To: Ryan Fogle
U.S. Environmental Protection Agency

From: Brandon Clay
True Manufacturing Company

Subject: ENERGY STAR Version 2.0 Laboratory Grade Refrigerators and Freezers Draft 2: True Mfg Comments

Figure 1. Plot of Energy Consumption vs. Internal Volume for High Performance Lab Grade Refrigerators listed on the QPL with the ENERGY STAR v2.0 proposed solid door and glass door criteria lines.

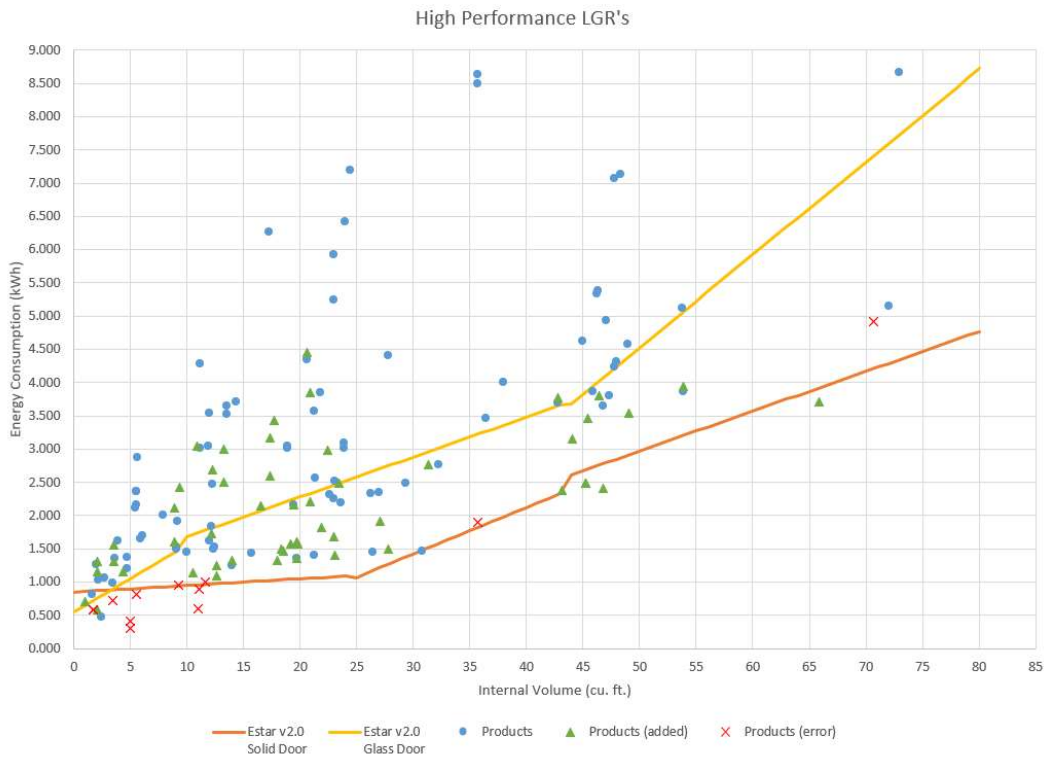
First, a new qualified product list (QPL) was pulled from the *ENERGY STAR Product Finder* [3] on March 11, 2024. We found 54 unique, High Performance LGR models that are not listed on the *Anonymized Data Set*. On Figure 1, the original models listed on the *Anonymized Data Set* are shown with a blue circle marker and the additional 54 models are shown by a green triangle marker.

On the contrary, there are 4 High Performance LGR models listed on the *Anonymized Data Set* that are no longer listed on the QPL. These models are shown with red "X" markers on Figure 1. There are also data points where the energy consumption listed on the *Anonymized Data Set* and QPL appear to be misreported. The energy consumption of these models is significantly different than models of similar type and size. Further investigation showed that the energy consumption listed on the QPL is considerably different than what the manufacturer is marketing on their specification sheet. On Figure 1, these data points are shown with red "X" markers.

Another reason the MDEC formula for the glass door High Performance LGR's needs reconsideration, is that there is a range where a glass door model will have a lower kWh requirement than an equivalent solid door model (see Fig. 1). A door completely insulated with polyurethane foam will always have a higher thermal resistance than an equally sized door with a glass insert, and thus, we would always expect a solid door model to consume less energy than an equivalent glass door model.

We recommend that all the MDEC formulas and passing rates are reevaluated with the latest QPL. The data in the QPL needs to be verified by reviewing the data submitted by the certification body.

We suggest that a new formula for the glass door High Performance LGR ($0 < V < 10$ bin) be considered that would ensure that the energy consumption requirement is always higher than a solid door of the same internal volume. Also, using the latest QPL data, the new formula should have the same pass rate as the other bins.

Figure 2. Plot of Energy Consumption vs. Internal Volume for solid door High Performance Lab Grade Refrigerators listed on the QPL with the ENERGY STAR v2.0 proposed solid door criteria lines.

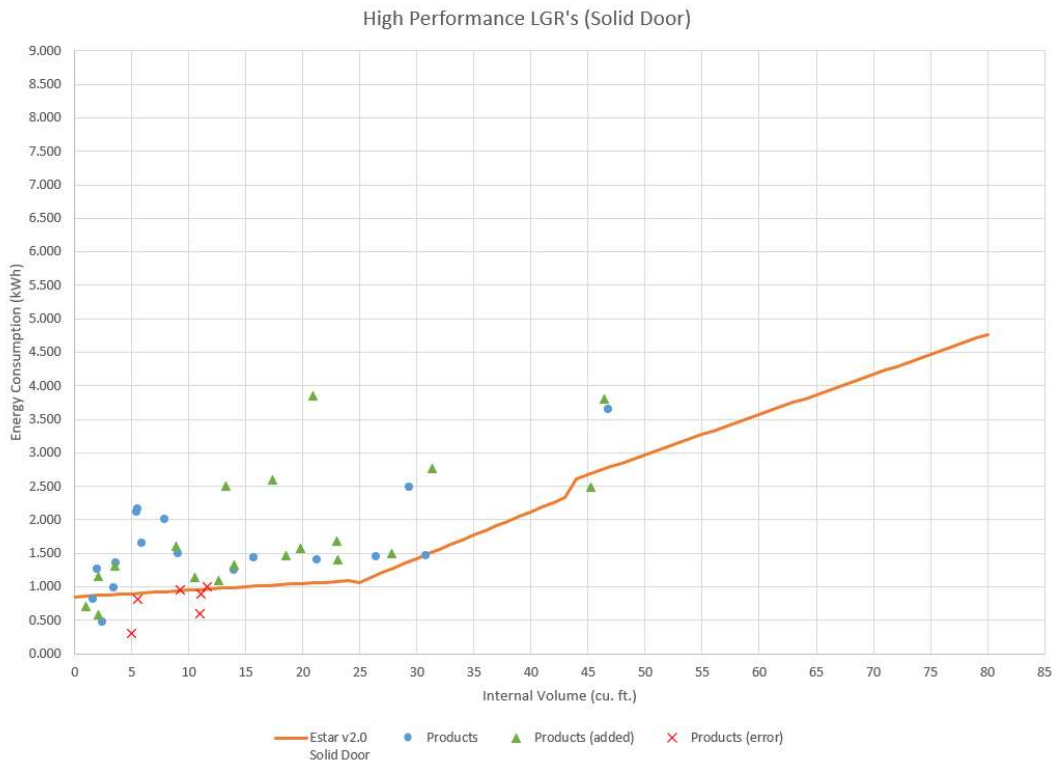
We believe that the MDEC formulas for solid door High Performance LGR's will create a greater reduction in qualifying products than intended and the formulas need to be reconsidered. Looking at the data from the *Anonymized Data Set* without any of the considerations in the section above, 7 out of the 23 solid door High Performance LGR's will pass the ENERGY STAR v2.0 criteria. However, there would be 0 passing models in the 12 to 30 cu. ft. range. This is a common internal volume for a single door upright, a very popular cabinet

type in the laboratory and pharmaceutical market. Of all LGR and Lab Grade Freezer (LGF) models listed on the *Anonymized Data Set*, 40% fall within this range of internal volumes.

Furthermore, if we remove from the dataset the models that are no longer listed on the QPL or are misreported, only a total of 3 solid door High Performance LGR models will qualify for ENERGY STAR v2.0. There will be 0 products in the 3 to 30 cu. ft. range. This is significant because 72% of the LGR and LGF models listed on the *Anonymized Data Set* are between 3 and 30 cu. ft.

A plot of the data for solid door High Performance LGR's is shown in Figure 2 below.

To have such a large segment of solid door LGR's not qualify for ENERGY STAR would cause confusion in the market and make it difficult for the end users to differentiate between high and low efficiency models. We recommend new MDEC formulas for the solid door High Performance LGR's that have higher energy consumption allowances.

Figure 3. Plot of Energy Consumption vs. Internal Volume for glass door High Performance Lab Grade Refrigerators listed on the QPL with the ENERGY STAR v2.0 proposed solid door criteria lines.

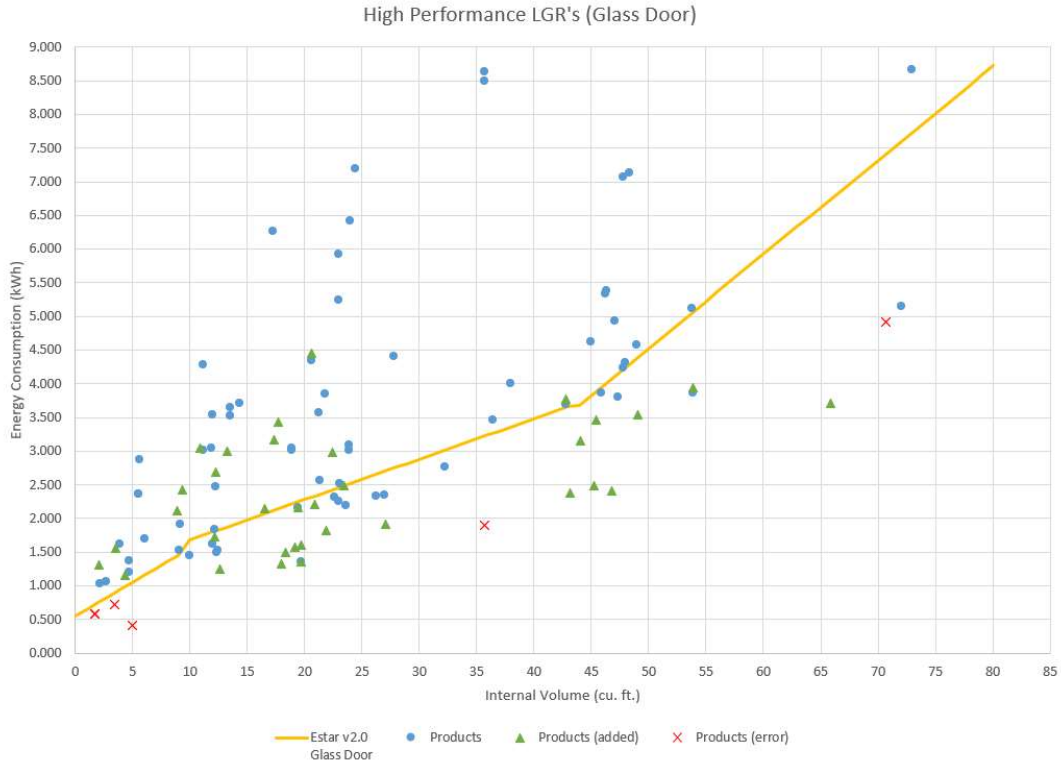
We believe that the MDEC formulas for glass door High Performance LGR's will create a greater reduction in qualifying products than intended and the formulas need to be reconsidered, in particular for the $0 < V < 10$ cubic foot bin. Looking at the data from the *Anonymized Data Set*, there are 3 out of 15 (20%) glass door High Performance LGR's in this bin that would pass the ENERGY STAR v2.0 criteria. This is much lower than the overall pass rate for glass door High Performance LGR's of 29%.

When removing the models that are no longer listed on the QPL or that are misreported, there will be 0 models meeting the criteria.

A plot of the data for glass door High Performance LGR's is shown in Figure 3 below.
